Access Compliance Report

Public Rights-of-Way

(Curb Ramps)

Intersection ID: 5514	Main Street: SUNSET_RD	Cross Street: MILHAVEN_LN	Location: NW
ADA ID: 523690302FEC	Ramp Type: Para	Initial Pass/Fail: Pass	Overall Compliance: No
		Severity Score: 2.5

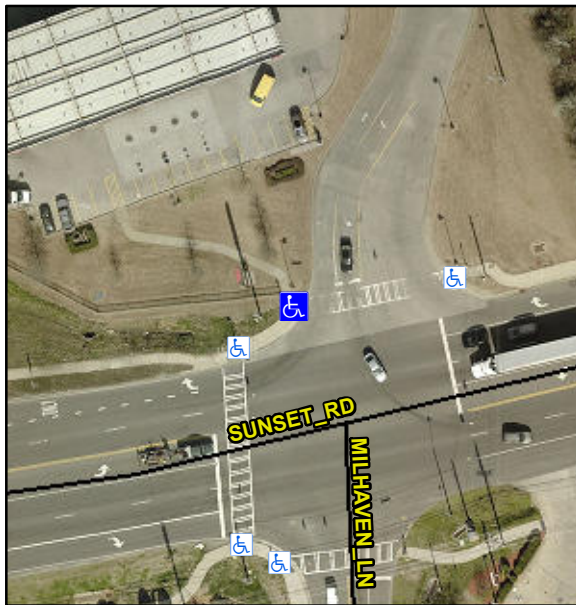
R305.1.4, R305.2

Compliance	Description	Data	Compliance	Description	Data
N/A	Ramp Length LT (in)	93.0	N/A	Ramp Length RT (in)	N/A
Yes	Ramp Width LT (in)	58.0	N/A	Ramp Width RT (in)	N/A
Yes	Ramp Slope LT (%)	7.3	N/A	Ramp Slope RT (%)	N/A
Yes	Ramp XSlope LT (%)	0.8	N/A	Ramp XSlope RT (%)	N/A
Yes	Landing Length (in)	59.0	Yes	DWS Provided?	Yes
Yes	Landing Width (in)	60.0	Yes	DWS Contrast?	Yes
Yes	Landing Slope (%)	1.0	Yes	DWS Length (in)	24.0
Yes	Landing X Slope (%)	1.0	No	DWS Full Width?	No
N/A	Landing Curb? (Y/N)	No	No	DWS Offset (in)	N/A
N/A	Shared Landing?	No			
Yes	Gutter Ponding?	No	Yes	Gutter Slope (%)	1.4
Yes	Gutter Lip Ht (in)	0.0	Yes	Gutter X Slope (%)	0.6
N/A	Painted X Walk1?	Yes	N/A	Painted X Walk2?	N/A
	X Walk 1 Direction	To E		X Walk 2 Direction	N/A
N/A	X Walk 1 Width (in)	106.0	N/A	X Walk 2 Width (in)	N/A
	X Walk 1 Slope (%)	0.3		X Walk 2 Slope (%)	N/A
	X Walk 1 X Slope (%)	2.0		X Walk 2 X Slope (%)	N/A
Yes	Ramp inside XWalk1?	Yes	N/A	Ramp inside XWalk2?	N/A

Remove & Replace Entire Ramp.
